**SPECIAL COUNCIL ASSESSMENT PANEL MEETING**

**AGENDA – 8.1**

<b>Applicant:</b> Woodside Heritage Village Pty Ltd	<b>Landowner:</b> Woodside Heritage Village Pty Ltd
<b>Agent:</b> Emma Barnes, Planning Studio	<b>Originating Officer:</b> Sarah Davenport
<b>Development Application:</b>	21/355/473
<b>Application Description:</b> Construction of new light industry building to include a distillery & tasting room, retaining walls (maximum height 4.6m), associated earthworks, landscaping & water storage tanks	
<b>Subject Land:</b> Lot:102 Sec: P5047 DP:61958 CT:5900/756	<b>General Location:</b> 1 /20 Henry Street Woodside <b>Attachment – Locality Plan</b>
<b>Development Plan Consolidated :</b> 8 August 2019 <b>Map AdHi/18 &amp; AdHi/ 57</b>	<b>Zone/Policy Area:</b> Light Industry Zone - Light Industry (Woodside) Policy Area (72)
<b>Form of Development:</b> Merit	<b>Site Area:</b> 7285 m <sup>2</sup>
<b>Public Notice Category:</b> Category 2	<b>Representations Received:</b> Two (2)  <b>Representations to be Heard:</b> One (1)

The proposal seeks Development Plan Consent for the construction of a new light industry building for the purposes of a distillery & tasting room and includes eart

**Figure 1: Material Illegally dumped over ROW - Area 'E'**

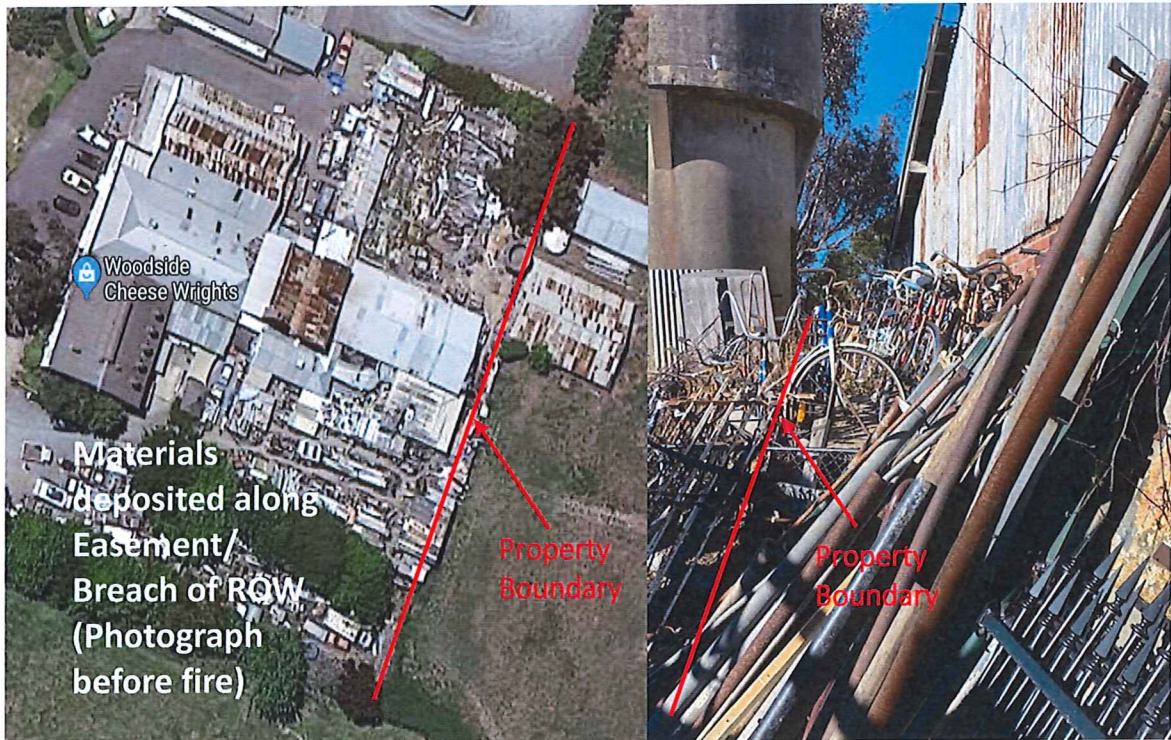
Our client's property includes a one metre wide strip of land, 91.7 metres in length, abutting the southern boundary of Lot 102 and extending to Henry Street where our client's water meter is located. For the 18 years that Mr. Armour has owned Lot 103, Mr Roberts has dumped rubbish along that portion of our client's property. That rubbish has comprised iron pipe, steel, scrap timber, scrap bricks and pavers, sawdust and other materials. This has prevented the proper burying of our client's mains water pipe. This, along with Mr Robert's continuous and ongoing breach of the Easement, reflect poorly upon his conduct, both as a neighbour and local businessman. That entrenched behaviour highlights the imperative to resolve Easement extinguishment and boundary fencing matters ahead of consent being granted for the proposed development.

**Figure 2: Earthworks by Lot 102 Illegally Extending over Lot 103**

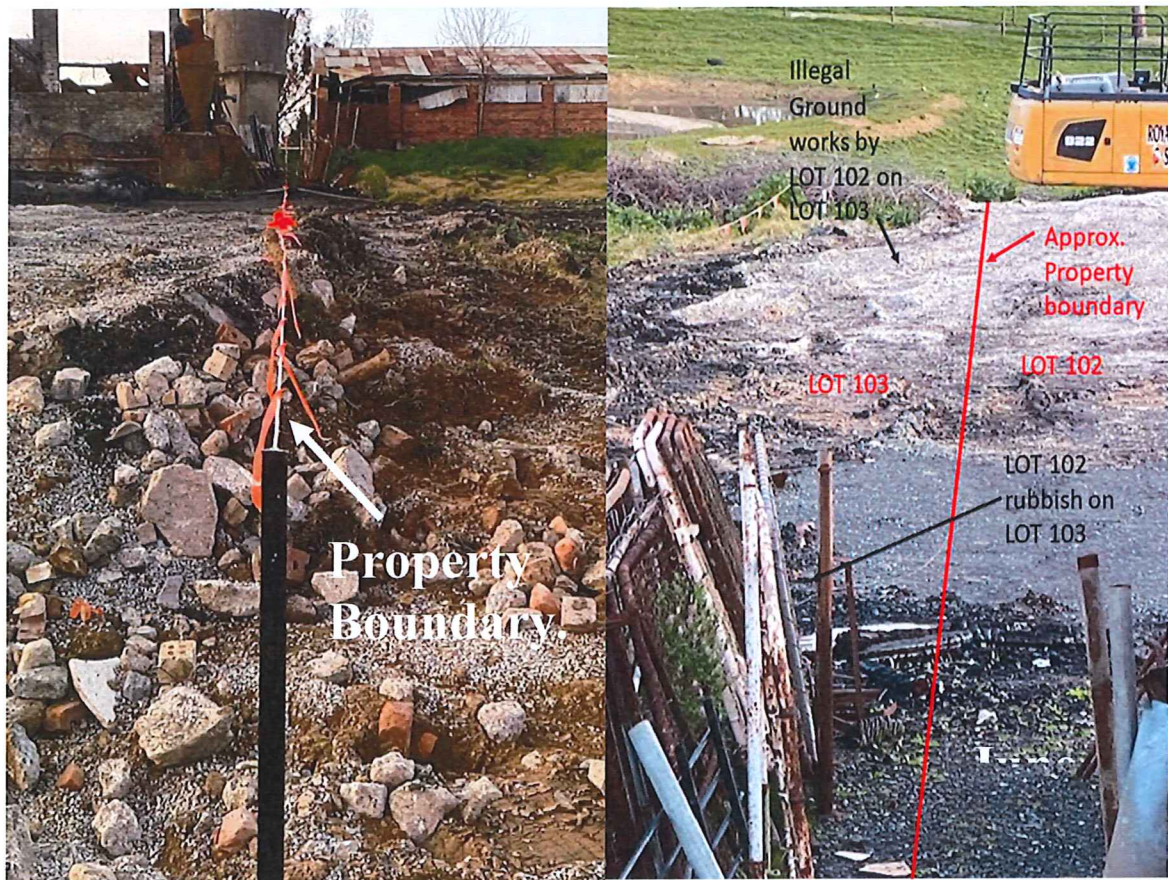
In June 2020, Mr Roberts undertook groundworks that extended across the property boundary to include approximately 40 square metres of Lot 103 land (Figure 2). At its highest point this altered the natural ground level on Lot 103 by 1.2 metres, creating an erosion problem for Lot 103 that did not previously exist. That fill had to be removed by our client.

**Figure 2** | Original proposal for Eastern Elevation (amended at request of Council)

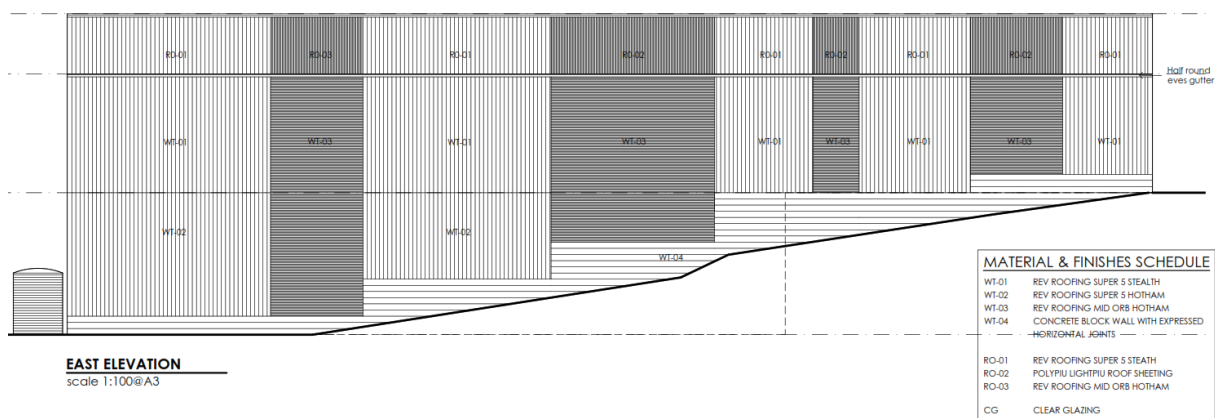
At Council's request, the southern and eastern elevation were changed to a solid colour to align with Council's preference for the building to be more in keeping with materials exhibited within rural areas, noting that buildings, such as farm buildings, wineries and horticulture buildings, which display similar wall heights are not an unusual occurrence within the Watershed Primary Production Zone.

Below is an extract from the original plans which depict contrasting colours on the proposed building. Should Council so desire, the proposal can revert to the original material selection to address the concerns of Mr Armour.
